PROBLEM Solver™ BULLETIN

Alignment Adjustability Restrictions

1999-2007
General Motors Trucks

REPLACEMENT BUSHINGS

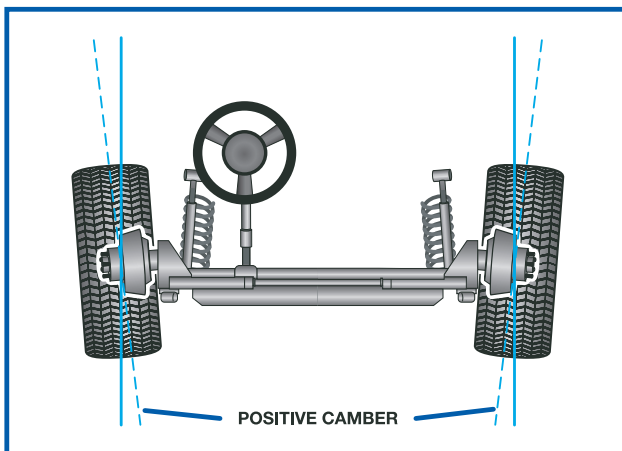
Alignment adjustability restrictions

- OE adjustments may not provide adequate range to obtain a proper alignment on late model Chevrolet and GMC light trucks.
- Excessive positive or negative camber will cause the vehicle to pull left or right and will create wear on the inside or outside edge of the tire.

MOOG® upper control arm offset bushings for camber and caster

- Provides an effective, low-cost means of obtaining more camber (and/or caster).
- Offers an additional 2 degrees of camber change.
- Used with factory cam adjuster, but allows greater range.
- Designed with OE-type material to maintain ride quality and service life.
- Fast and simple installation – made easier with the use of T40259, a bushing adapter specially designed to work with K6669 and K6670.
